PLEASE REPLACE OLD BOLT MSX35 MM DIN 912

AURA - CUSTOM CERVELO

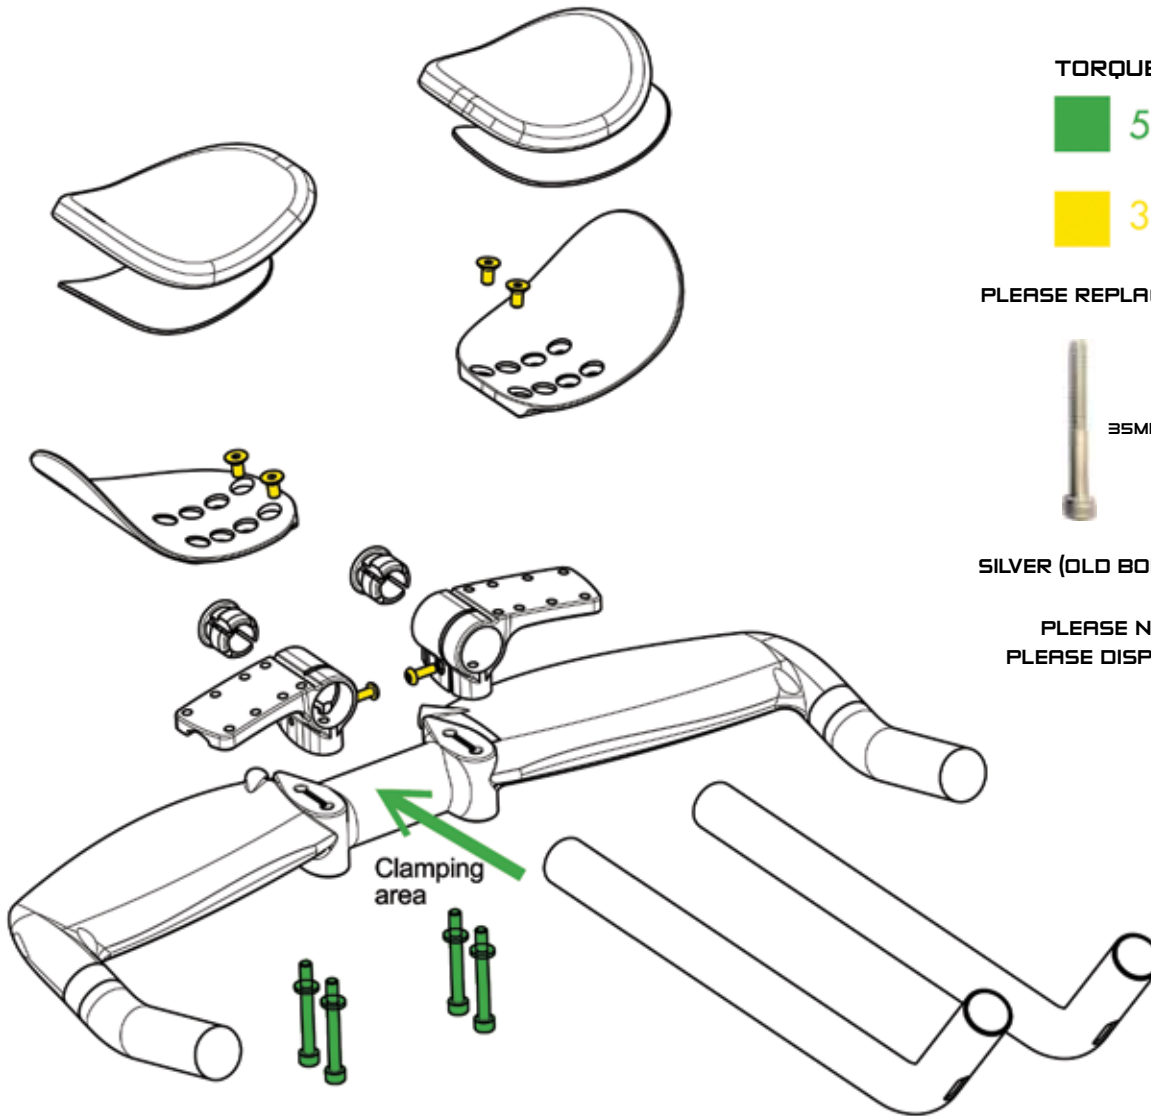
PLEASE NOTE NEW BOLTS ARE BLACK
PLEASE DISPOSE OLD BOLTS (SILVER COLOR)

> REPLACE >

45MM

BLACK (NEW BOLT)
